# UNITED STATES PATENT AND TRADEMARK OFFICE

10/533,030

## Office Action Summary

## **DETAILED ACTION**

本発明の工程説明図 Procedure Diagrams of Present Invention

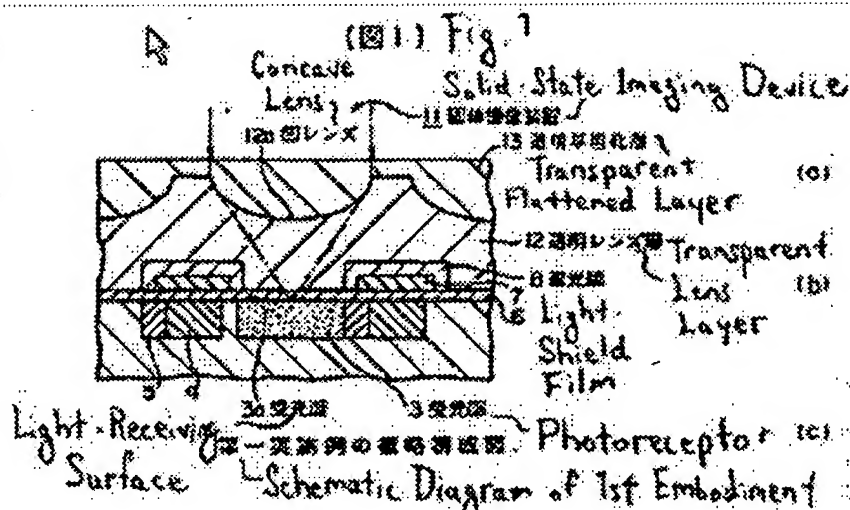
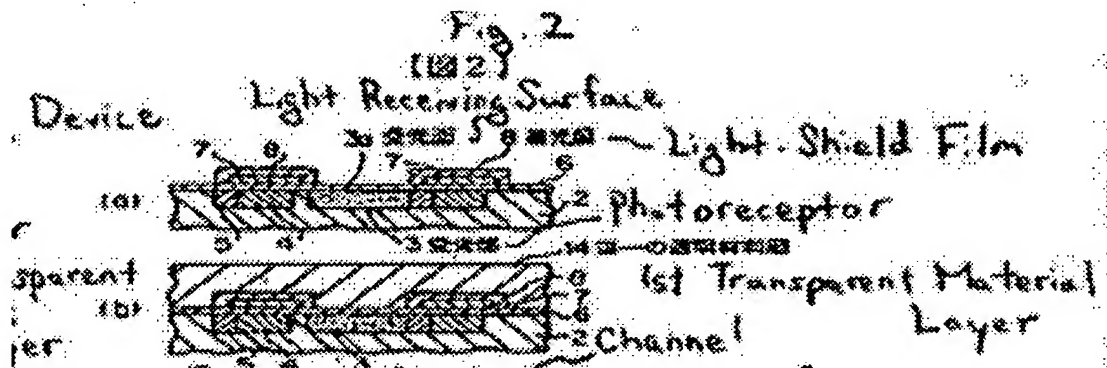
6. As for claim 5, Suzuki discloses and shows in Figs. 1, 2c, and 2f a method of manufacturing a solid state imaging device comprising:

- a. an insulating film (12/14) etching step for etching a fiat light transmitting insulating film along a predetermined mask pattern to form convex regions between adjacent micro lenses (Suzuki discloses (Pages 10 – 12, [0017] - [0018]) the use of etching to create the convex form of the layer);
- b. a lens film laminating step for laminating a light transmitting lens film (13) on the insulating film; and;
- c. an etching step by etch back processing of the lens film (Suzuki discloses (Pages 10 – 11, [0017] – [0018]) that the flattening process of layer 17, which is also applied to the layer 13, is done by etching the same).

7. Suzuki fails to disclose the creation of concave regions over the convex regions when flattening the lens film (13).

**FIG. 6 ( c )**

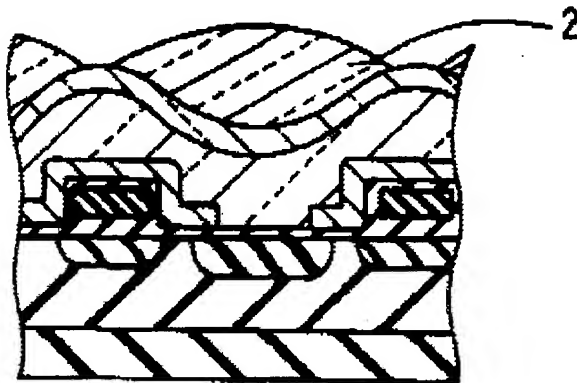
8. Sano discloses (Col. 11, lines 15 – 30) and shows in Fig. 6(a) – 6(c) the method of crating a concave lens (2) on top of a convex region in a solid state imaging device by etching.

9. Sano is evidence that ordinary workers in the art would find a reason, suggestion or motivation to create a concave lens on top of the convex region of the solid state imaging device.

**FIG. 3**

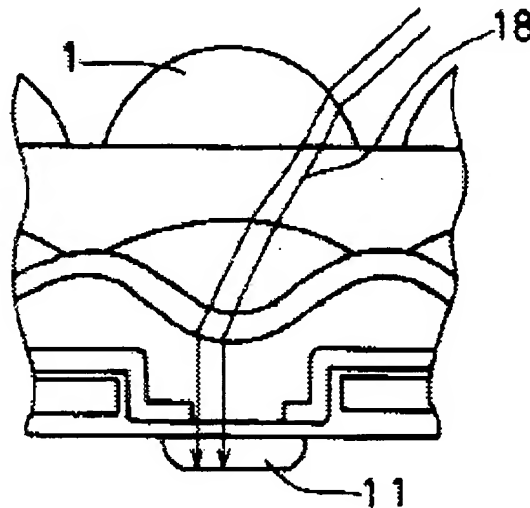
10. Therefore, it would have been obvious to one of ordinary skill in the art at the time of the invention was made to modify Suzuki by etching the flattening layer (13) all the way until creating a concave lens on top of the convex region of the solid state imaging device for advantages such as improving the sensitivity of the structure when the diaphragm of the optical lens is open (Col. 12, lines 3 – 7) as shown in Fig. 3.
